Hampshire
County Council

<i>Enquiries to</i>	Chris Hirst	<i>My reference</i>	6-3-13-187
<i>Direct Line</i>	0370 779 0563	<i>Your reference</i>	APP/21/01451
<i>Date</i>	8 th November 2023	<i>Email</i>	Chris.Hirst@hants.gov.uk

Reserved Matters application for the scale and appearance of the development, the landscaping of the site and the layout of buildings pursuant to Planning Permission ref. APP/17/00863 (B) (Outline Application (All Matters Reserved except means of access) for the demolition of 1983 office building and associated brick and glass corridor link and development of up to 70 residential units, associated landscaping, parking and infrastructure works). Request to Discharge Condition 17 of Planning Permission APP/17/00863 (B) as amended by APP/21/01292 (Design Code) and Condition 26 of Permission APP/17/00863 (B) (viability assessment). | Southleigh Park House, Eastleigh Road, Havant, PO9 2PE.

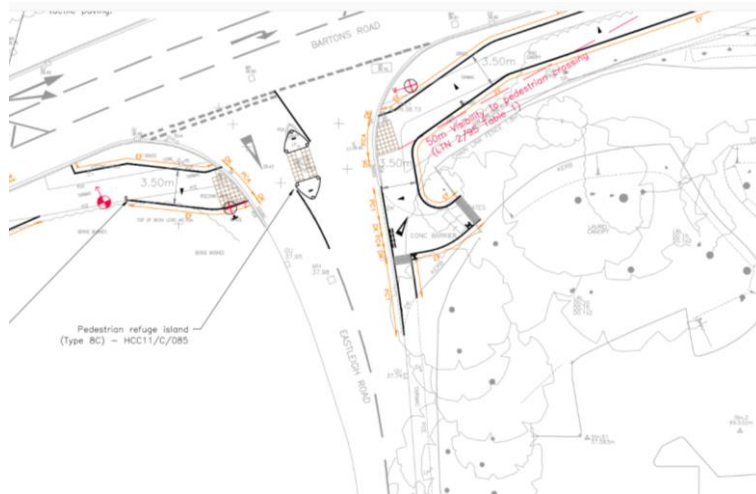
Specifically, the design drops cyclists from shared use provision into parking courts where conflicts could arise between manoeuvring vehicles and these more vulnerable road users. Opportunities to continue with cyclists off carriageway have not been realised throughout the current layout. Areas of connection for cyclists are annotated within the external works/hard surfacing plan 6281-MJA-SW-XX-DR-C-400 Ref PL3 and are shown to be hoggins footpath rather than for cyclists. It is unclear why tarmac provision is not being provided at these locations, especially where they link to proposed tarmac provision. The connection from the southern parcel is shown to be footway only and this should cater for cyclists to prevent the need to utilise Eastleigh Road. The current design does not facilitate cyclists from the main spine road

north in any way, again placing a reliance on cycling on Eastleigh Road which is considered unsuitable. The cycle infrastructure across the site is required to connect to the offsite provision at the northwestern corner of the development as shown below. In the absence of integration to this point the reserved matters application is not being brought forward in accordance with the hybrid permission.

The Highway Authority require the footway link to the north of Road 4 to be widened to 3m, alongside the east-west link to the south of Bartons Road, to allow cyclists to access the wider infrastructure without having to route via Eastleigh Road. This should be supported by widening of the footway to the south of Southleigh Park House to improve permeability for cyclists across the site. A direct route should also be provided north/south through the development site to support permeability for residents of the site itself as well as future wider connections. The Highway Authority does not agree that the current design adheres to HCC TG10 and the design has not taken into account the comments raised during the pre-app stage.
